ST TAMMANY PARISH ADMIN COMPLEX

CONT: NATCO CONST

RFI # 11

RF1 # 56

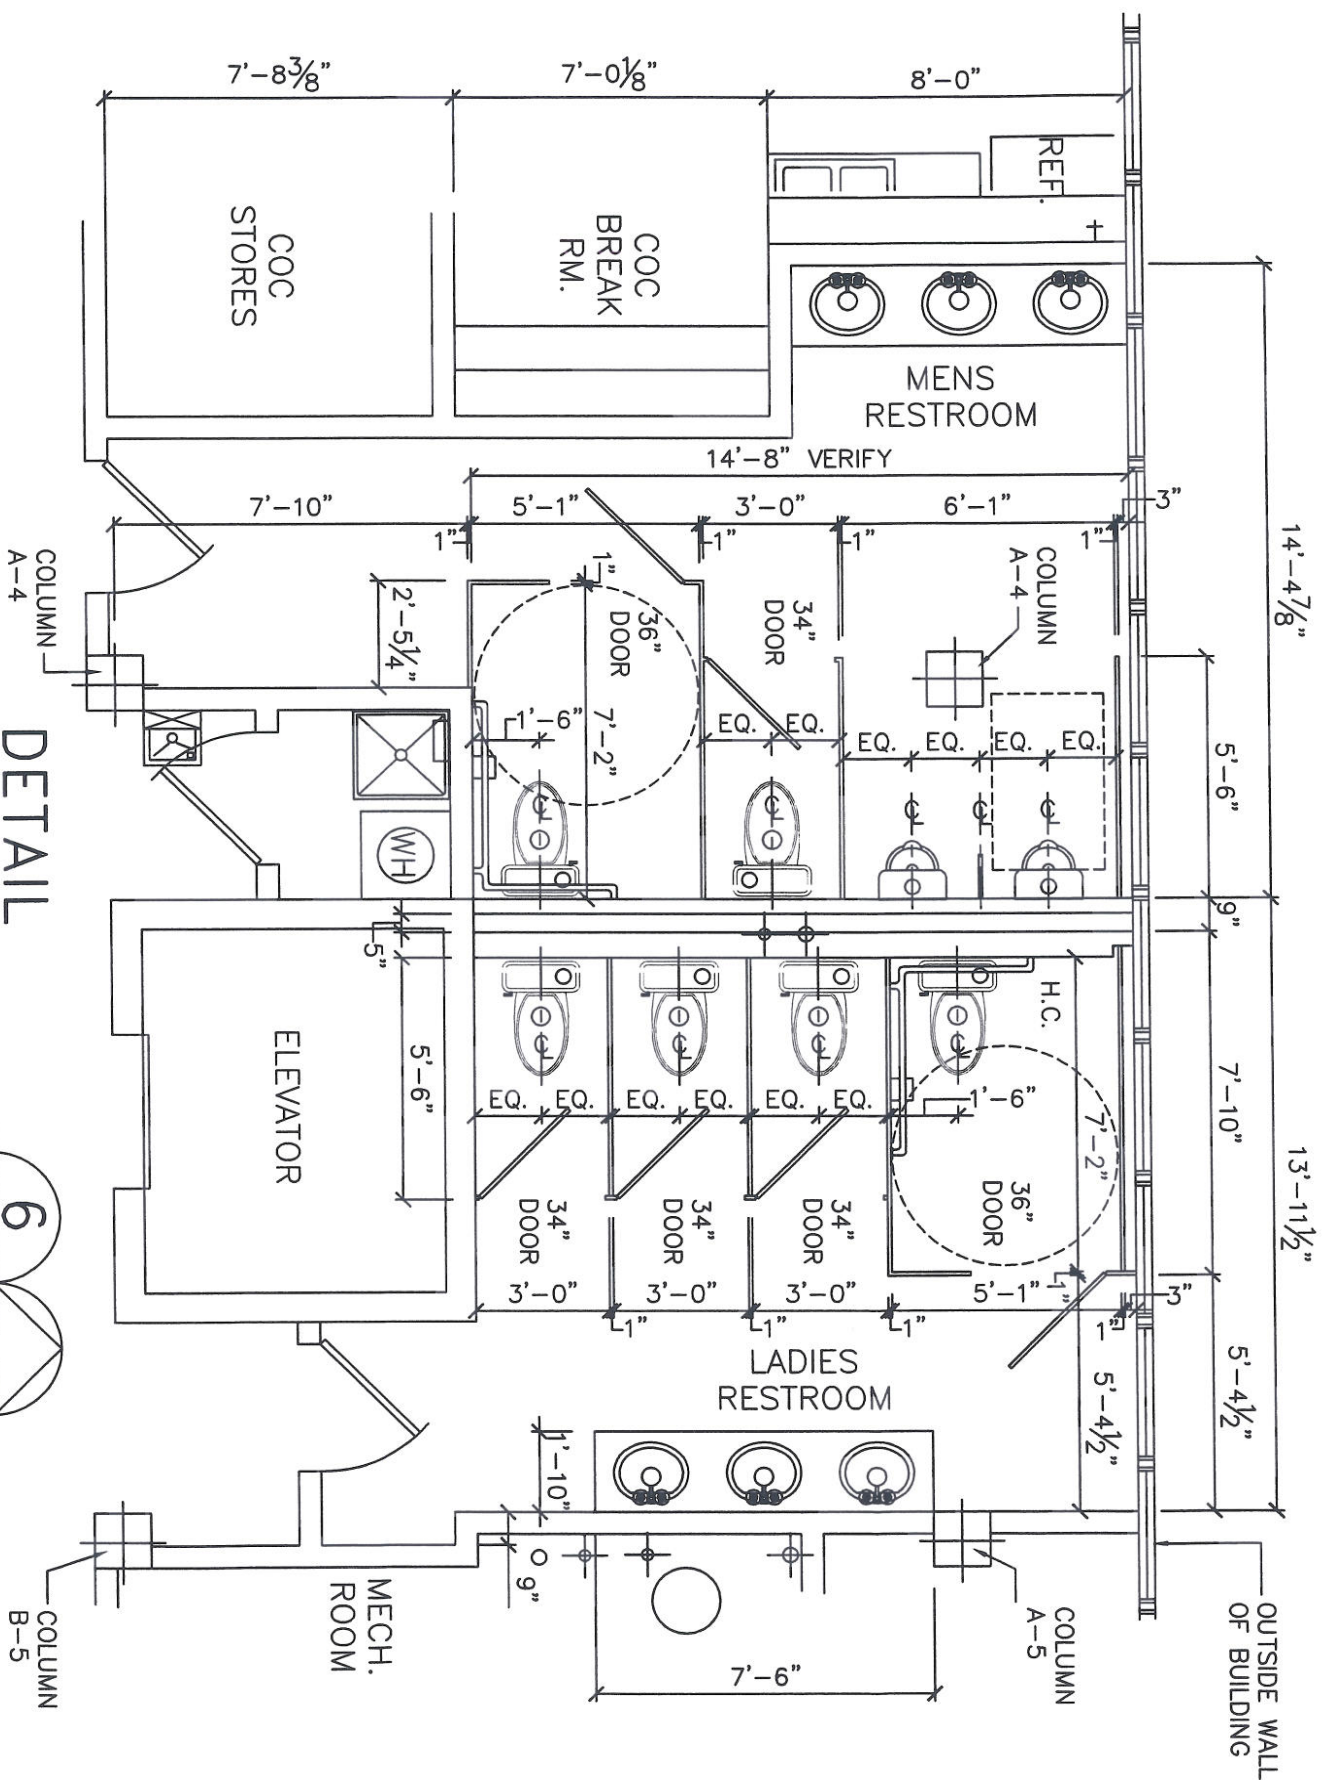
THIRD FLOOR REST ROOM
 FOURTH FLOOR TYPICAL

RF1 # 61

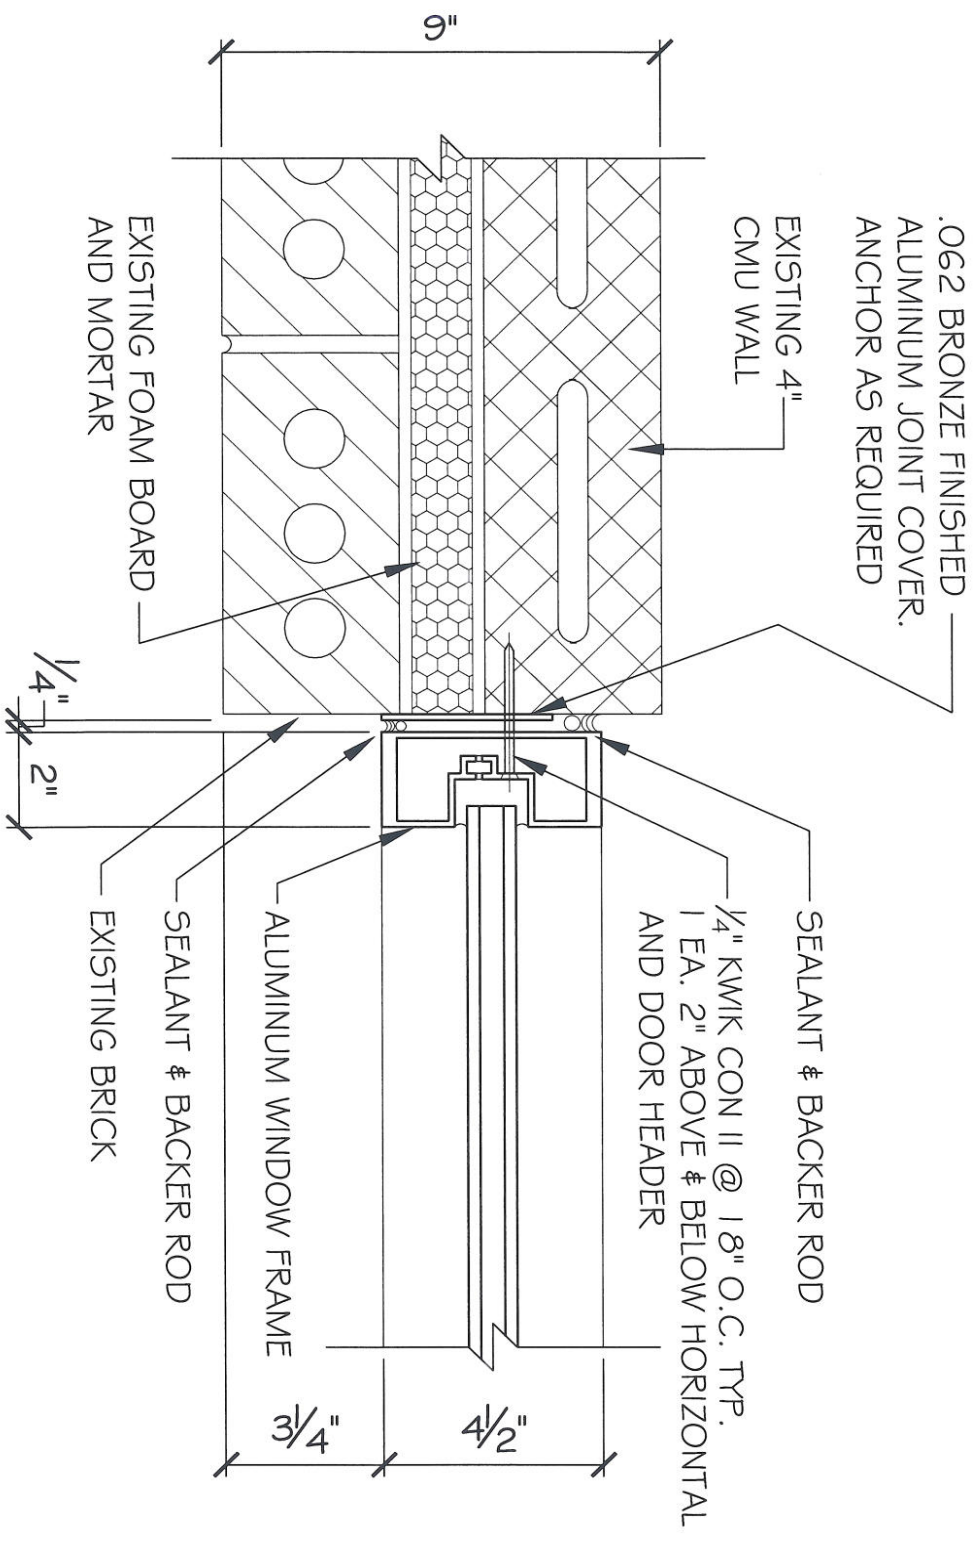
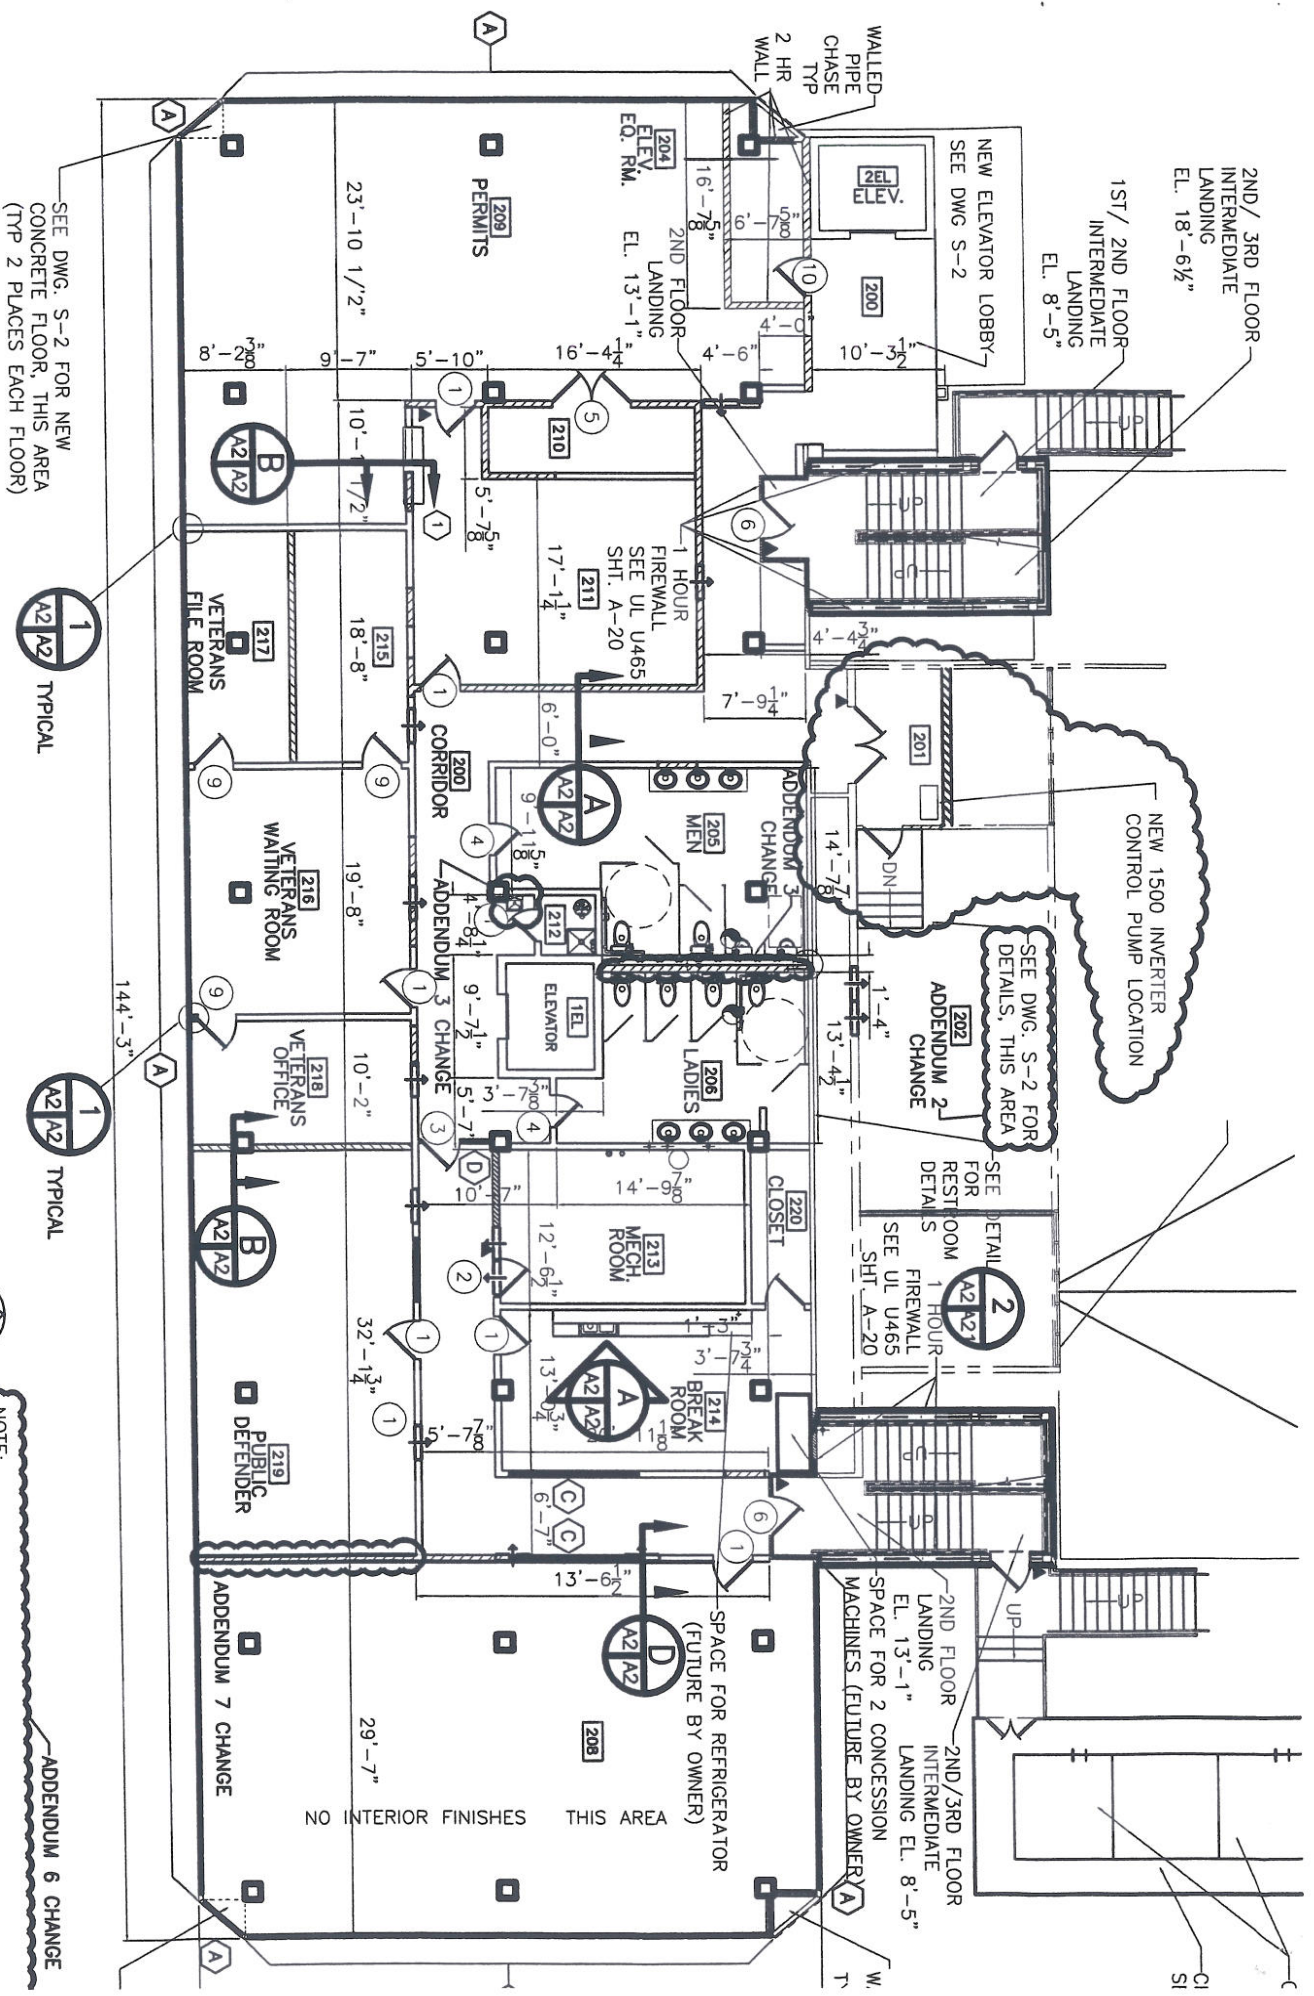
SEE DWG. S-2 FOR NEW CONCRETE FLOOR, THIS AREA (TYP 2 PLACES EACH FLOOR)

RFI # 100

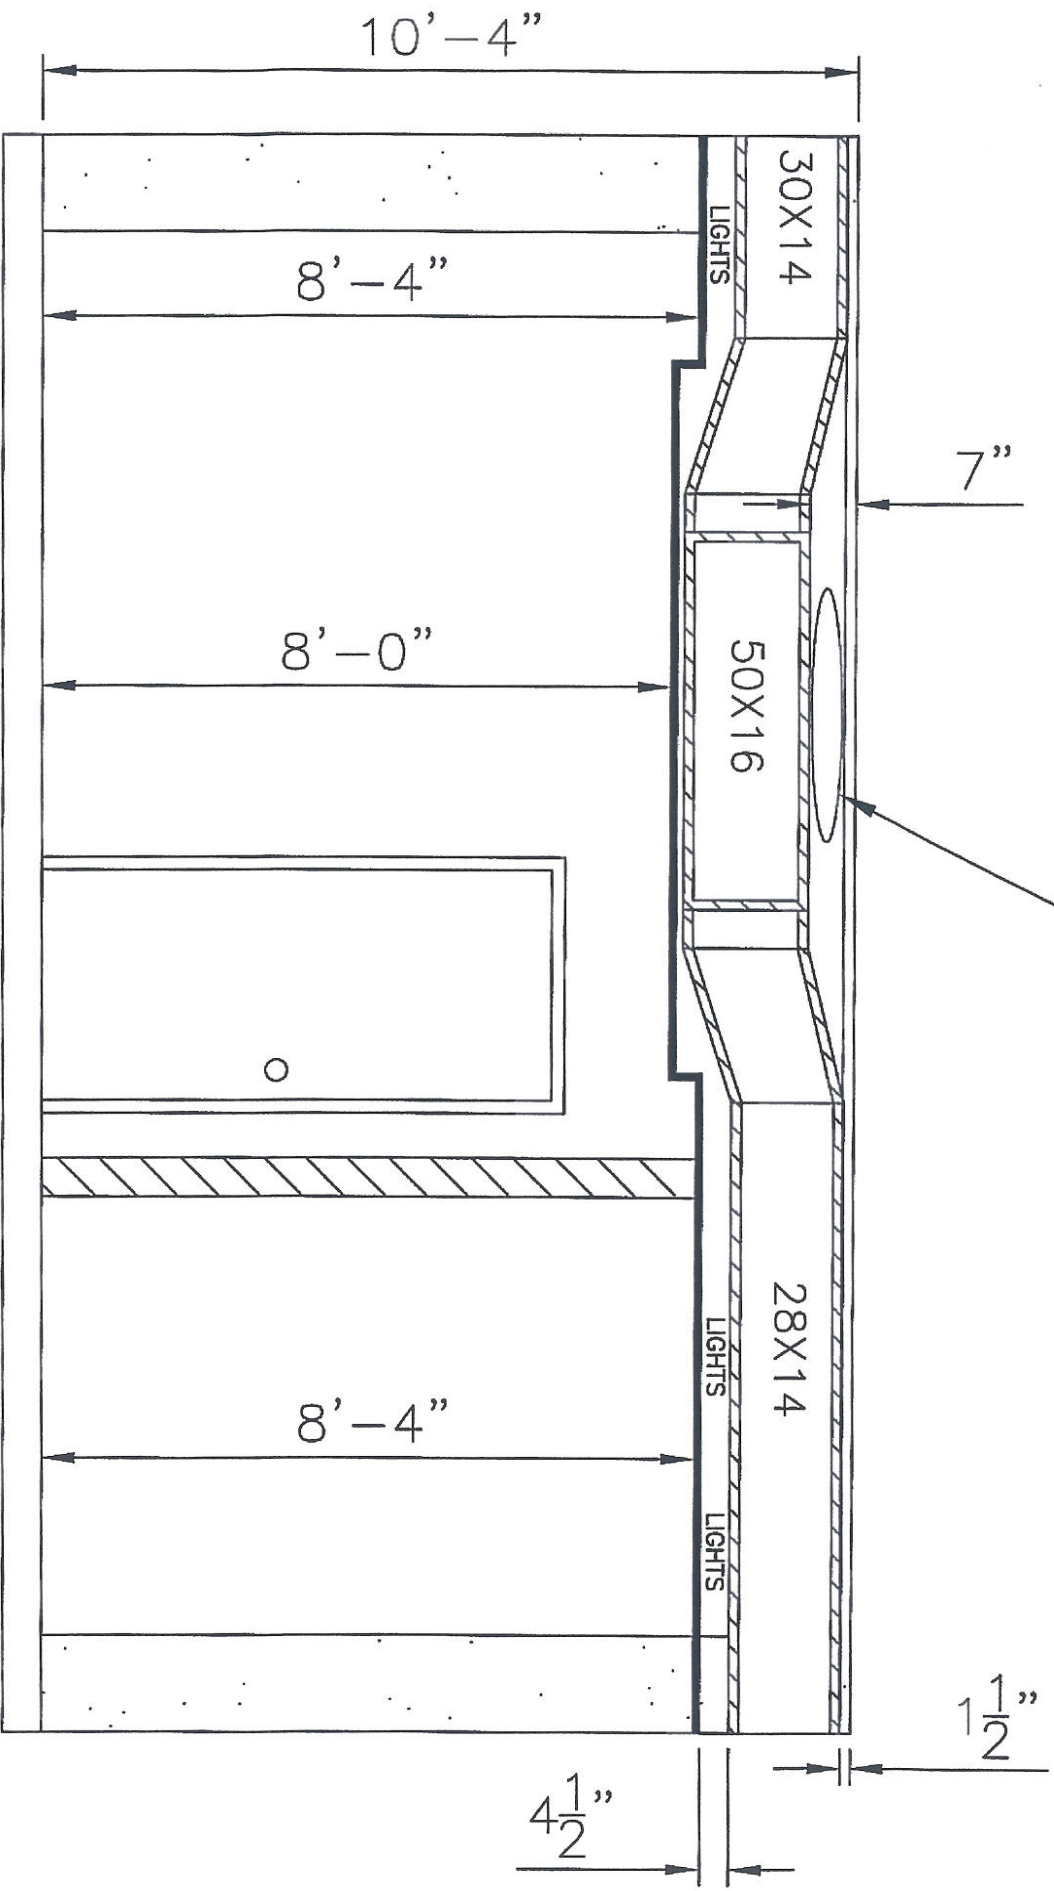
SPACE FOR CONDUIT,
PLUMBING, AND SPRINKLER
PIPING TO CROSS

MECHANICAL ROOM
MAIN DUCT
